NRC RAI Letter No. PTN-RAI-LTR-041

SRP Section: 02.05.01 - Basic Geologic and Seismic Information

NRC RAI Number: 02.05.01-33 (eRAI 6024)

Proposed Turkey Point Units 6 and 7
Docket Nos. 52-040 and 52-041
FPL Draft Revised Response to NRC RAI No. 02.05.01-33 (eRAI 6024)
Page 6 of 6

Figure 2. The two zones of secondary porosity on B-608 (DH) showing the lithology, caliper, natural gamma, velocity (Vs and Vp) and acoustic televiewer logs (1 of 5)

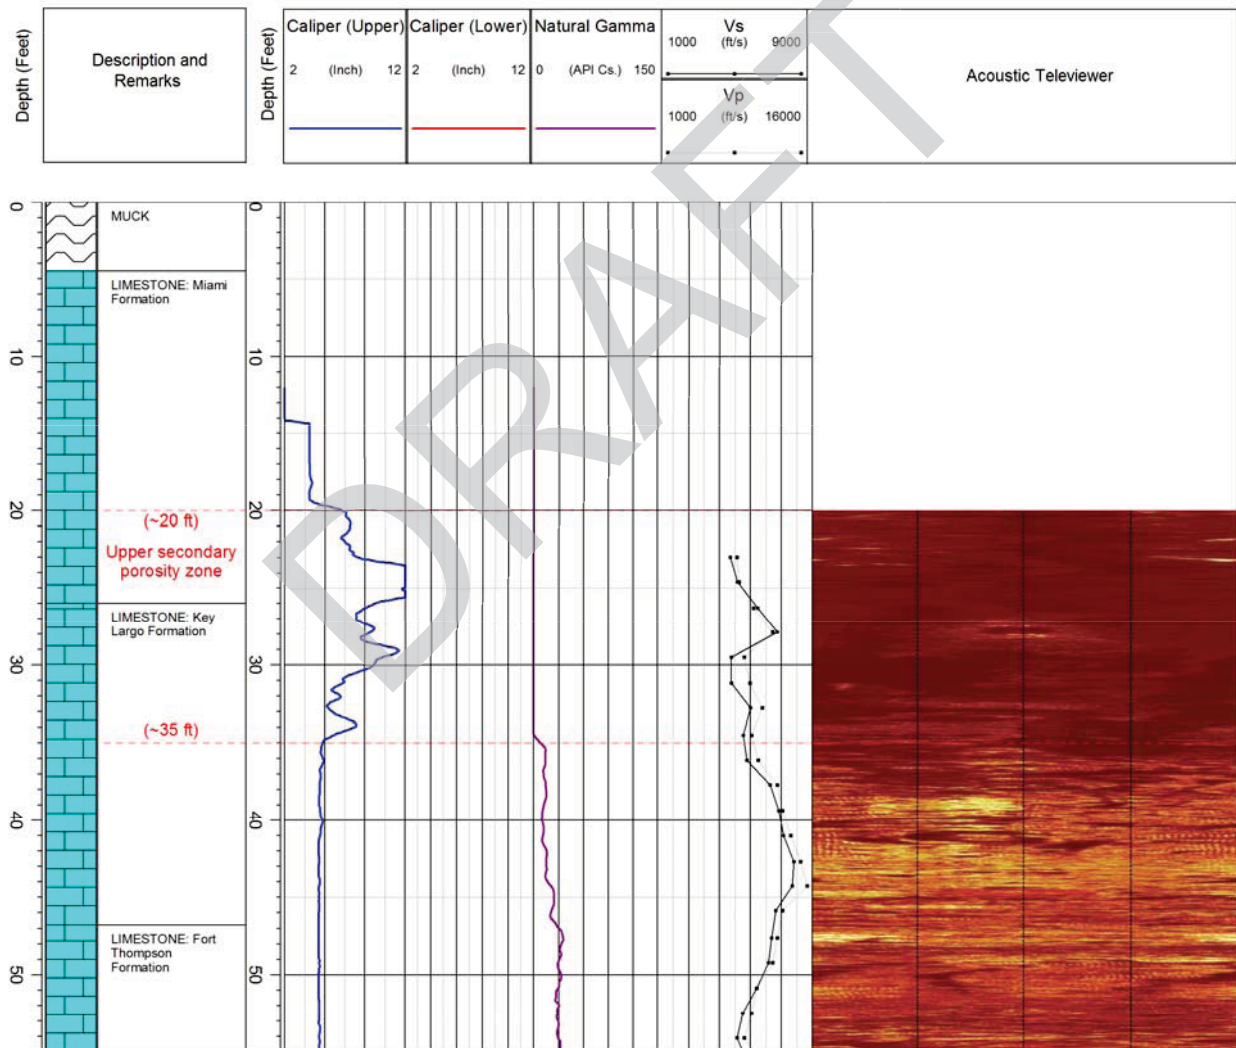
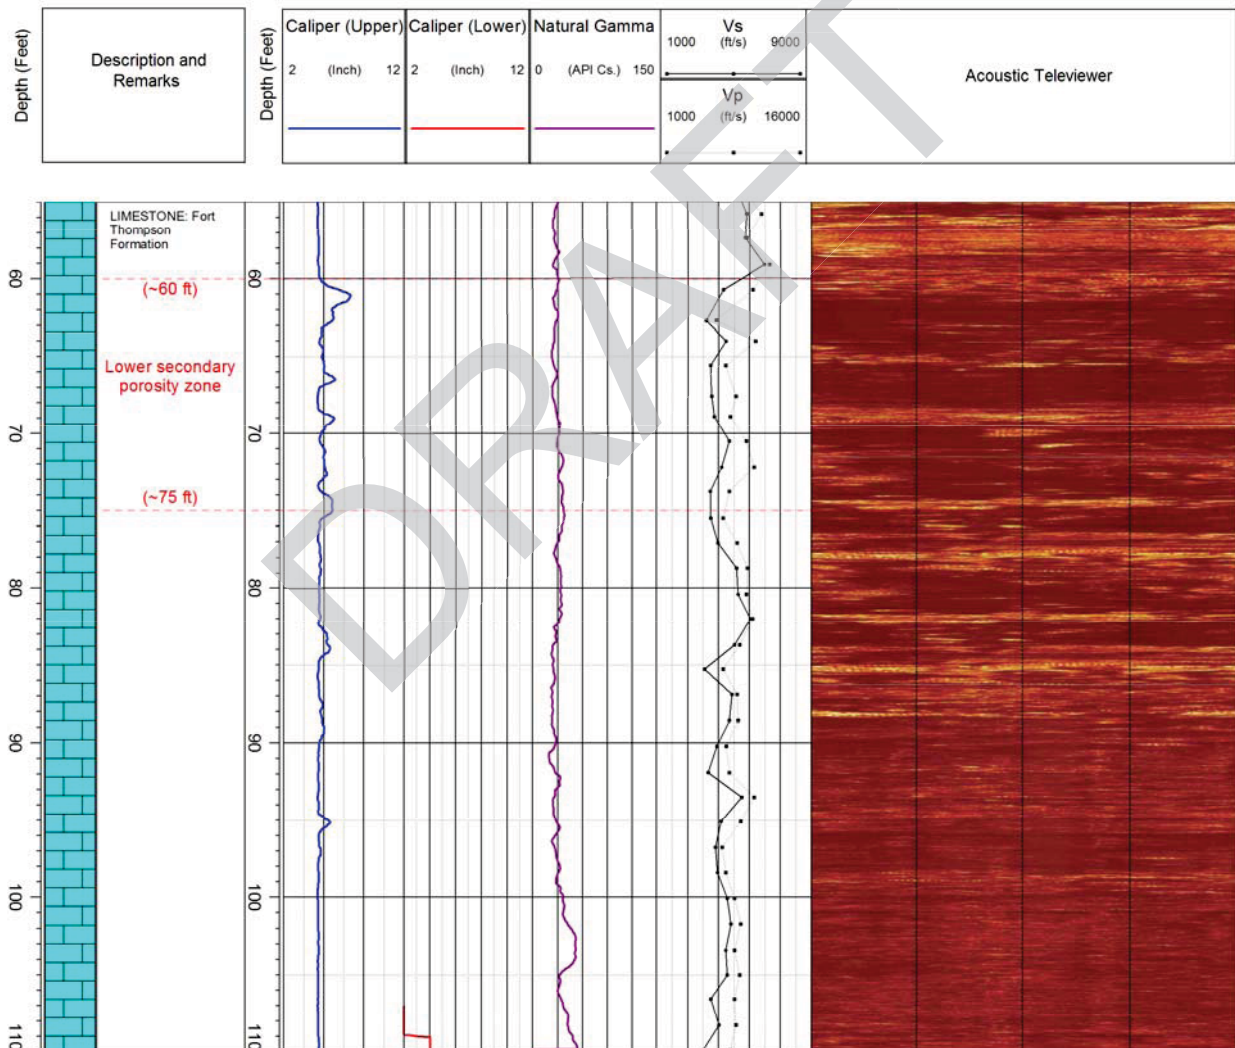
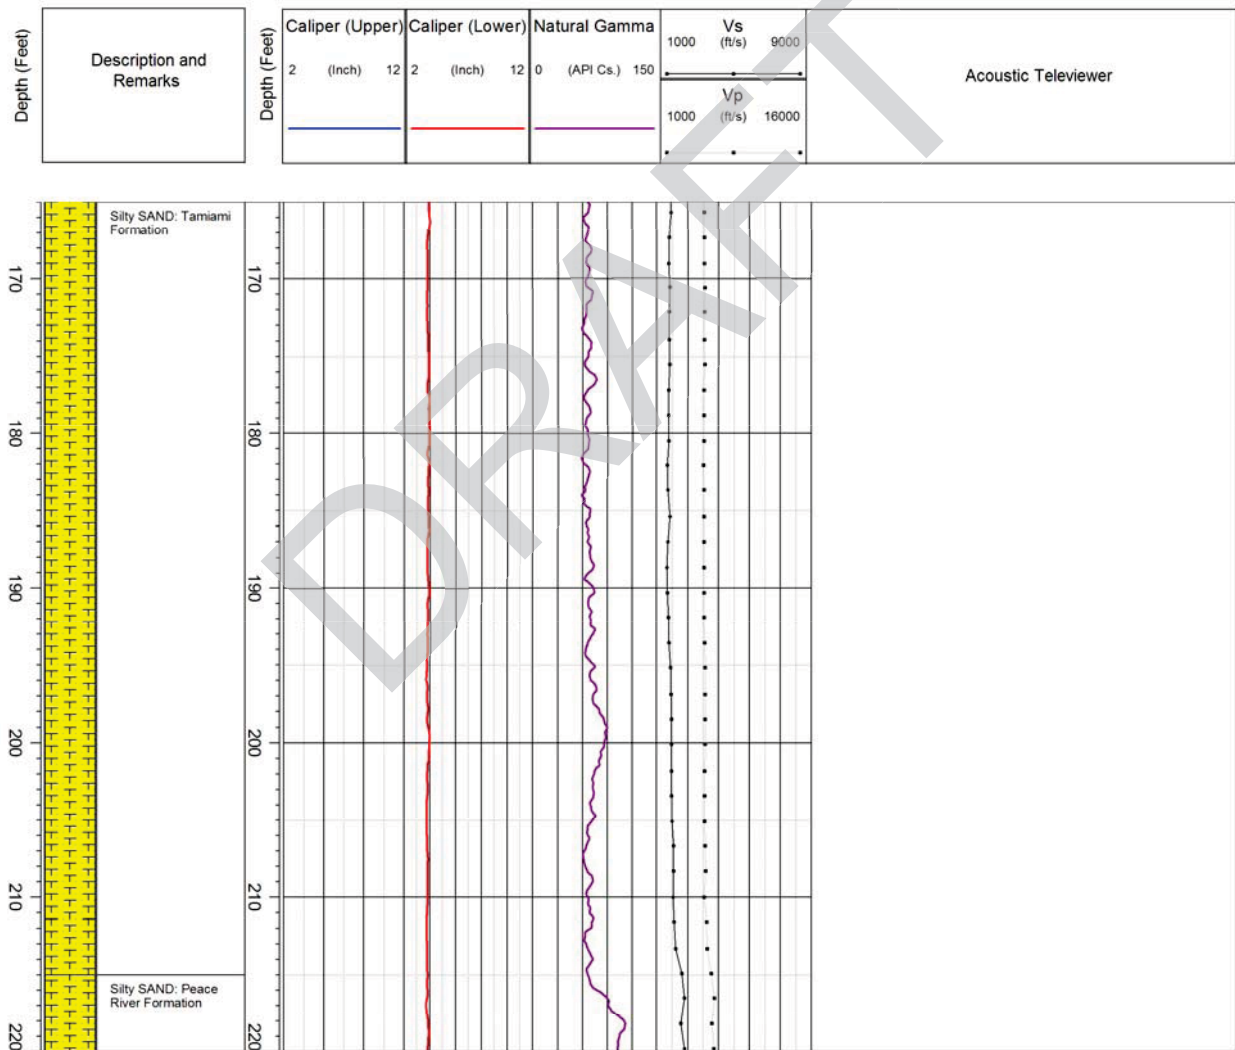
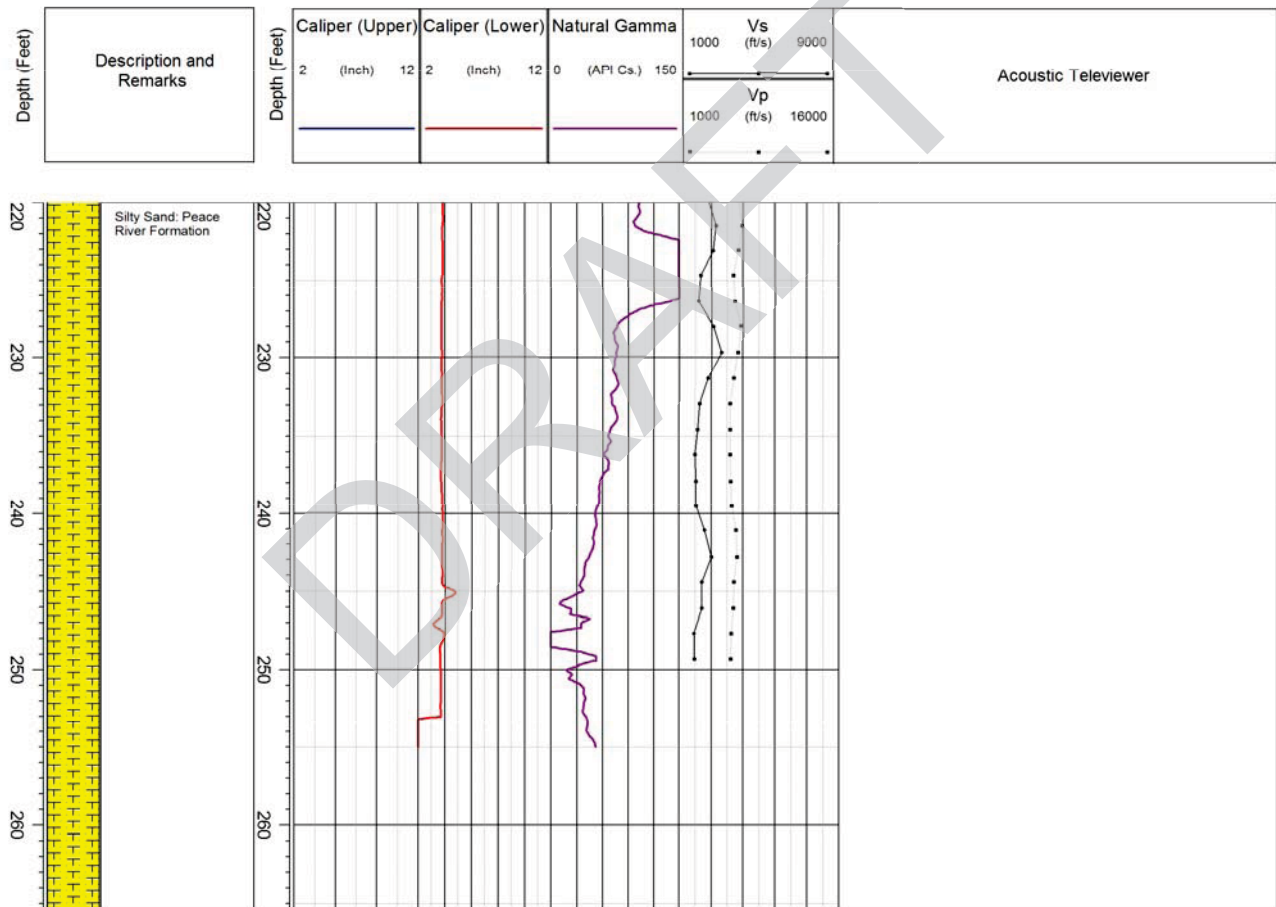
FSAR Section 2.5.1.2.4 discusses limestone dissolution features and states that zones of preferential secondary porosity exist within (1) an upper zone within Key Largo Limestone and (2) a lower zone within Fort Thompson Formation, and that these zones include cavities verified from televiwer and caliper logs. Staff notes that the Key Largo LS will be the bearing layer for SSC buildings. In order for the staff to evaluate the dissolution potential at the TPNPP site and in support of 10 CFR 100.23, please address the following:

- a) Discuss the possible origins of these subsurface voids and evaluate if this is still consistent with your statement “there is no evidence for sinkhole hazards or for the potential of surface collapse due to the presence of large underground openings” on page 2.5.1-229.
- b) Discuss the possibility that these zones of secondary porosity are in the same stratigraphic unit that expresses the karst/sinkhole-like features seen immediately off shore to the east of the TPNPP site.

As described in FSAR Subsection 2.5.1.2.4, the two zones of secondary porosity were identified at the site following review of the geophysical logs, the geotechnical boring logs, and the shear wave velocity logs. In general, the zones of secondary porosity were identified based on increases in borehole diameter on the caliper logs, darkened areas on the acoustic televiwer images, typically lower P-S wave velocity values, and loss of drilling fluid and rod drops. Figures 1 through 3 show the approximate locations of the two zones of secondary porosity on three example-boring logs, B-604 (DH), B-608 (DH), and B-710 G (DH) and their locations at the Turkey Point Units 6 & 7 site are seen on FSAR Figure 2.5.1-228 and FSAR

Figure 2.5.4-202. Figures 1 through 3 were compiled using the lithology, caliper, natural gamma, acoustic televiwer, and velocity (Vs and Vp) logs.
